- 3. Monk Acres; KPB File 2022-071
Peninsula Surveying LLC / Monk
Location: Snader Street & Classy Starla Avenue
Anchor Point Area / Anchor Point APC**

**PLAT OF
MONK ACRES**

ITEM 3 - MONK ACRES

STAFF REPORT

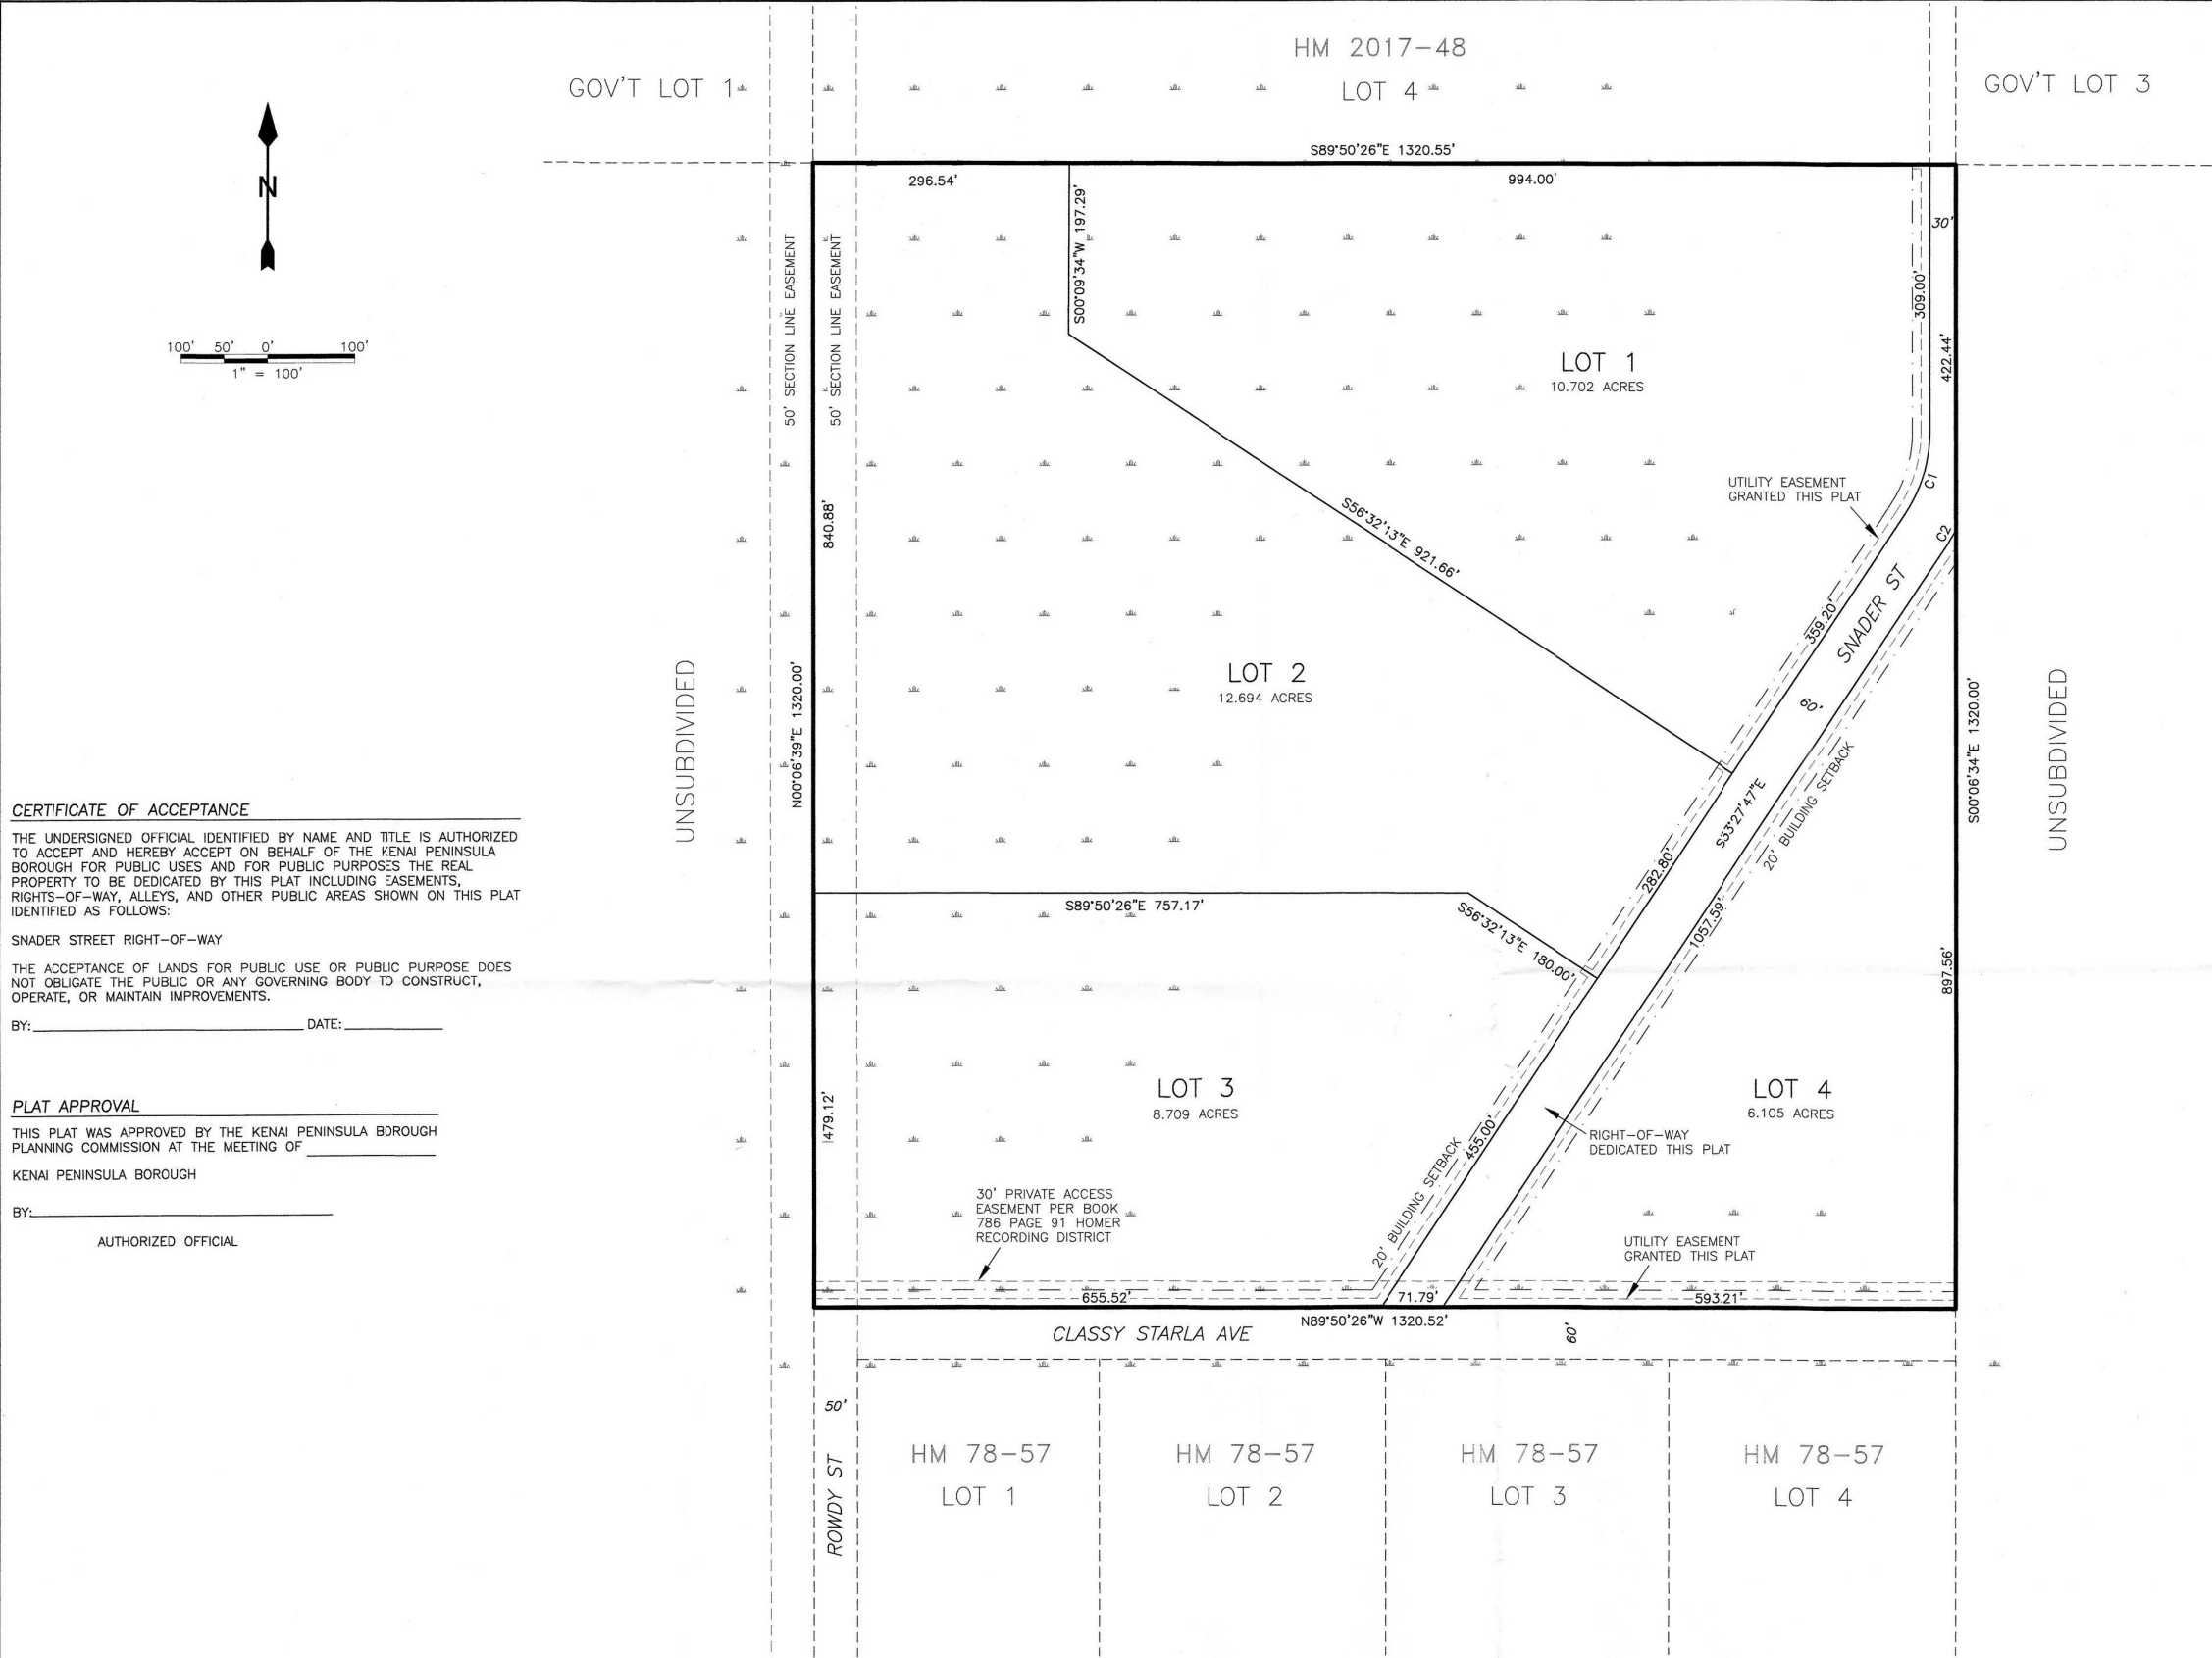
A private access easement was granted by document and is depicted and labeled along the southern boundary the subdivision. **Staff recommends the book and page numbers must be corrected to Book 91 and Page 786.**

Site Investigation: There does not appear to be any steep slopes present within the subdivision boundary. Low wet areas are present and are depicted on the final plat. The correct wetland determination note is present. **Staff recommends the wetland depiction remain on the final plat.**

The plat is proposing to grant 10 foot utility easements along the dedicated rights-of-way that will increase to 20 feet within 5 feet of the side lot lines. The depiction is present and includes "granted this plat". ***Staff recommends the plat note be revised to state "The front 10 feet adjoining dedicated rights-of-way that increase to 20 feet within 5 feet of the side lot lines is granted as utility easement by this plat."***

Staff recommendation: *Include an additional label for width and street name for Snader Street located north of the subdivision.*

Staff recommendation: *Verify the angle at the Snader Street and Classy Starla Avenue intersection. Staff finds that it is approximately 57 degrees. If the angle is less than 60 degrees, provide a compliant intersection.*

- *A note for any exceptions granted.*
- *Additional notes may be required if any possible encroachments are found within the setbacks or utility easements.*
